TETON COUNTY FAIRGROUNDS ARENA

ADDENDUM #3

(Construction Documents Revisions 1 and RFI Log)

Fairgrounds Arena
Phase 1- Indoor Arena Shell
Teton County ID

Building Sections

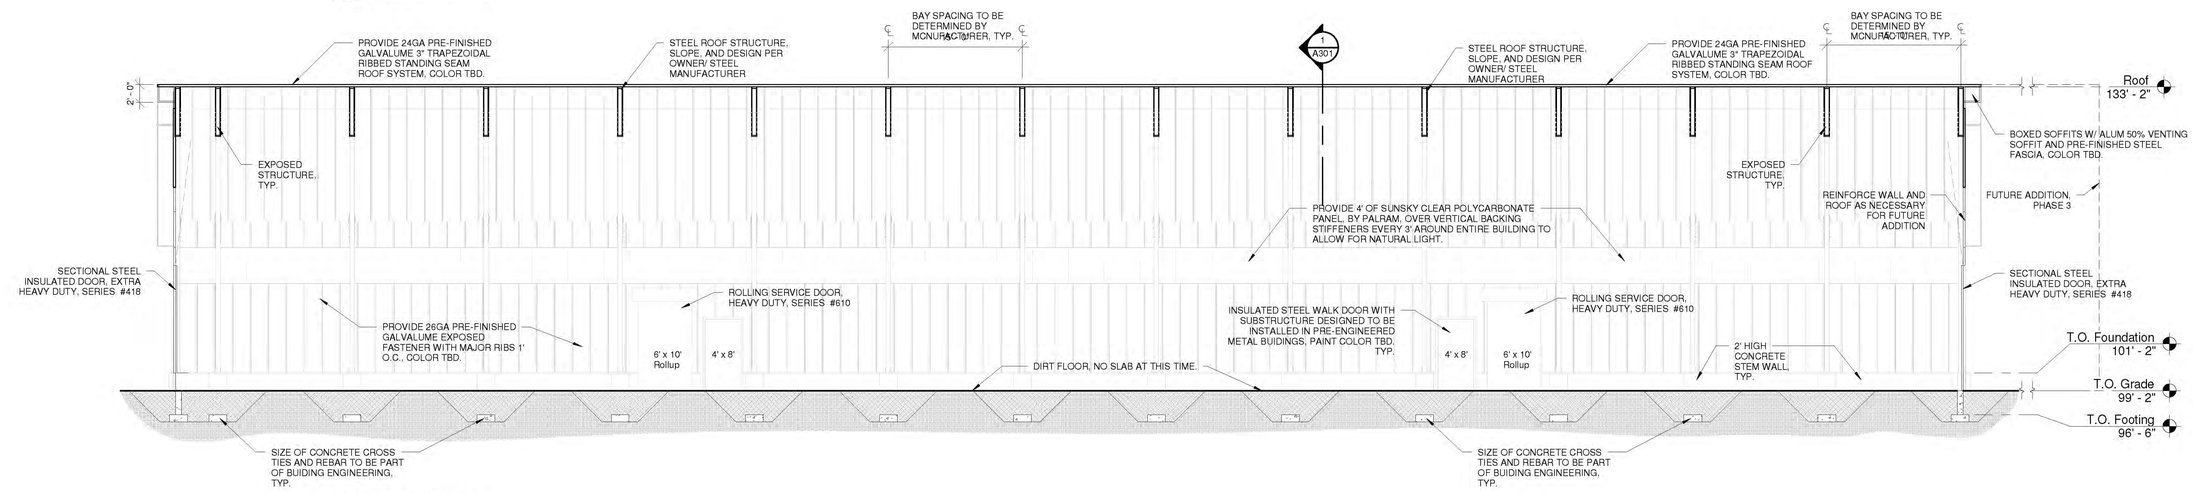
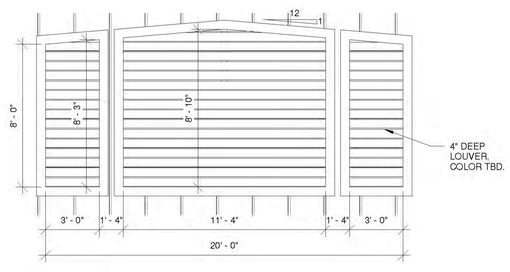
- A002 General Notes – Revised to be more project specific.
- A003 Site Plan – Noted to exclude all site work beyond arena shell from this Bid.
- A301 – Reference to "Painted" Steel Structure Removed

QUESTION: On Sheet A301 you call out painting the structure but there is no spec section for painting nor is there a line item under any of the alternates for painting, please clarify.
ANSWER: Painting of the interior steel structure will not be included in this Bid.

QUESTION: What is the material thickness of the louvers found on the gable ends for ventilation?
ANSWER: This thickness may vary between the various steel manufactures bidding the project, but we do know of one supplier that has a louver specified that has a material thickness of .081"

QUESTION: With the gable end vent louvers 8' above the large overhead doors, how should we attach the necessary springs and rails to operate the door?
ANSWER: Because of the louvers, it will not be possible to slide the door vertically all the way up the wall. To help increase the headroom in front of these doors yet stay away from the louvers, please plan on installing the door track hardware up the wall vertically to just below the louvers then out horizontally into the arena space. We will have to suspend part of this door track approximately 8' from the steel framing above.

A003
Site Plan

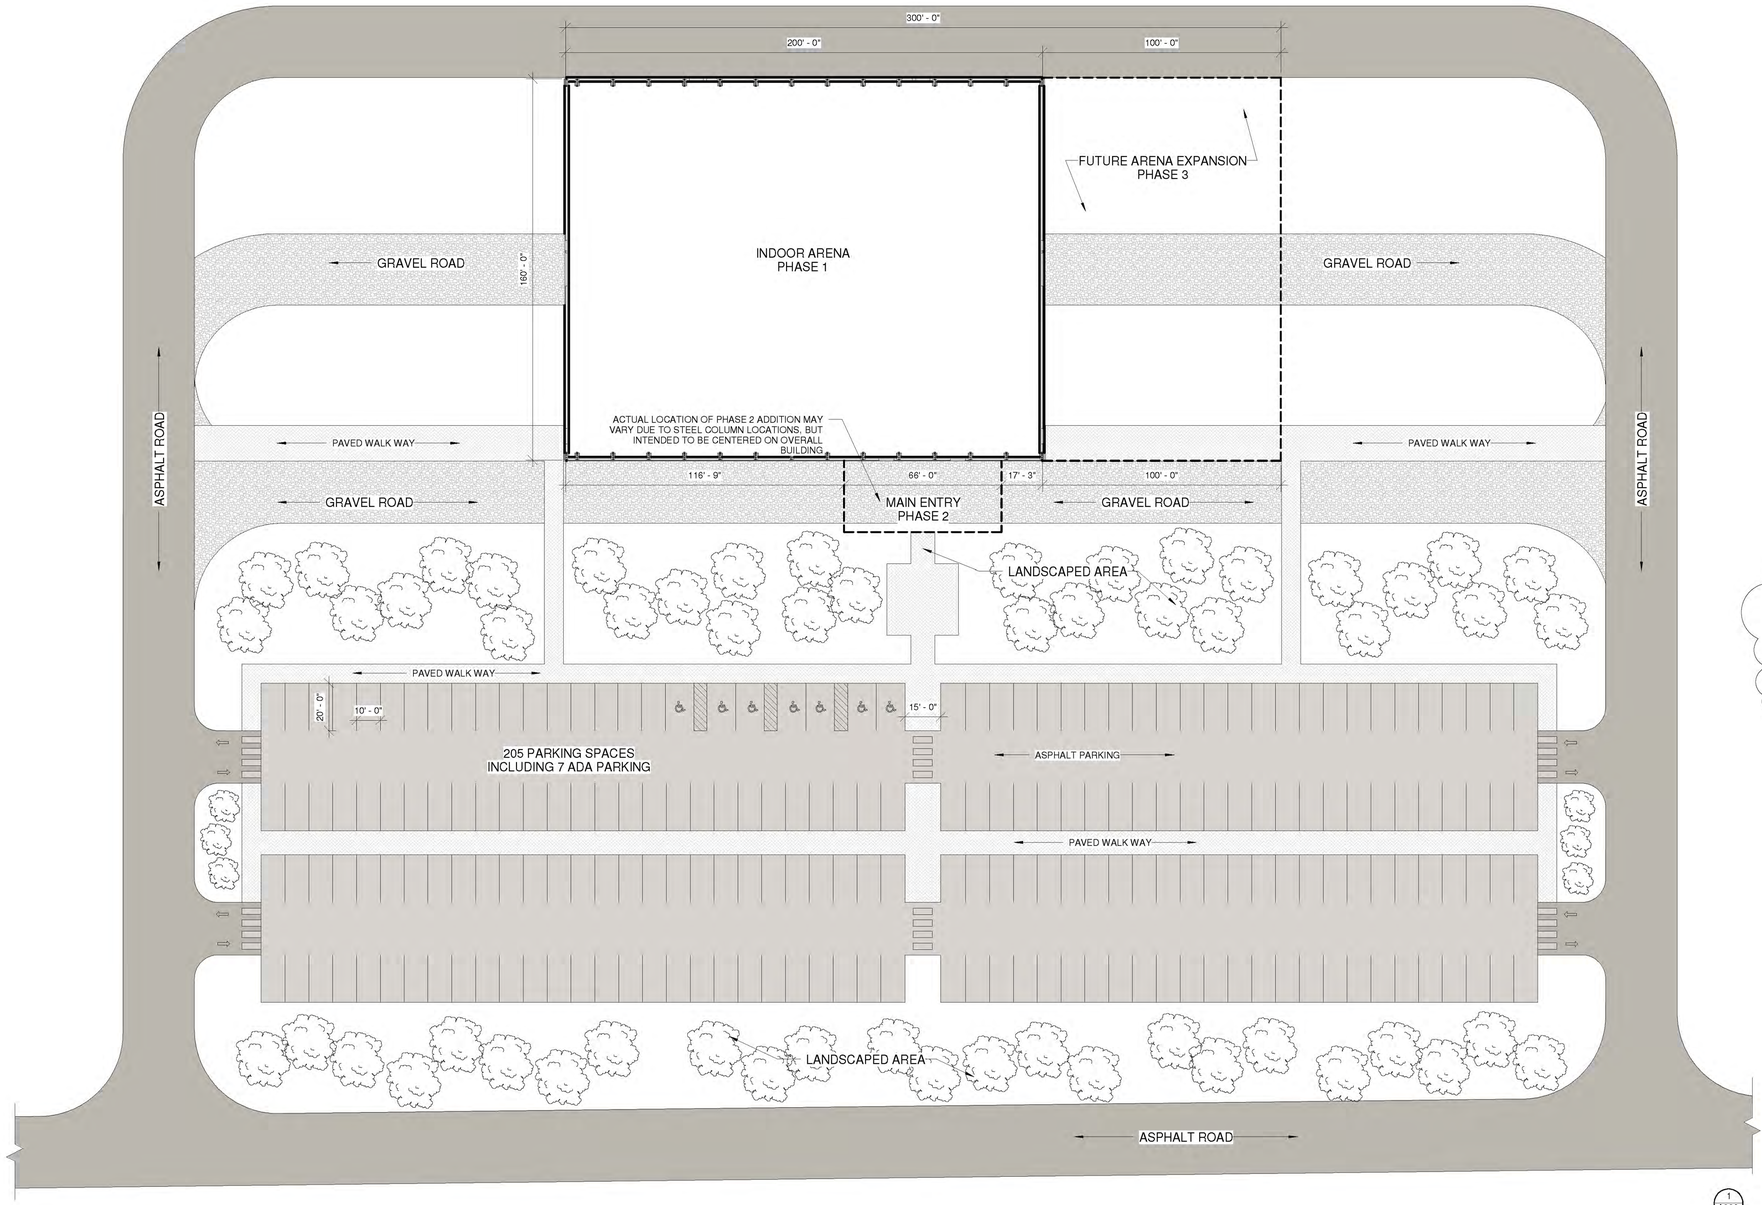
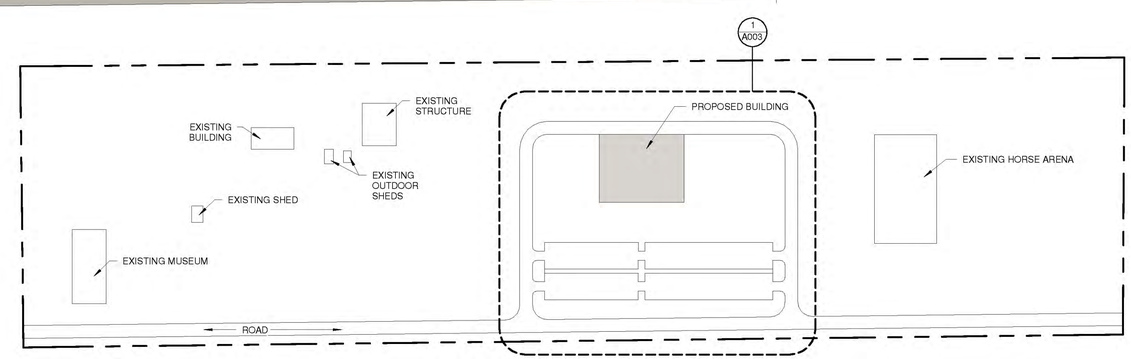
QUESTION: Sheet A003 shows parking, landscaping, please denote that this is in future work and not to be included in this bid.
ANSWER: All site work outside the scope of the Arena shell is not included in this Bid and will fall under a separate contract with Owner at a later date.

All sitework beyond arena shell are not included in this Bid and will fall under a seperate contract at a later date.
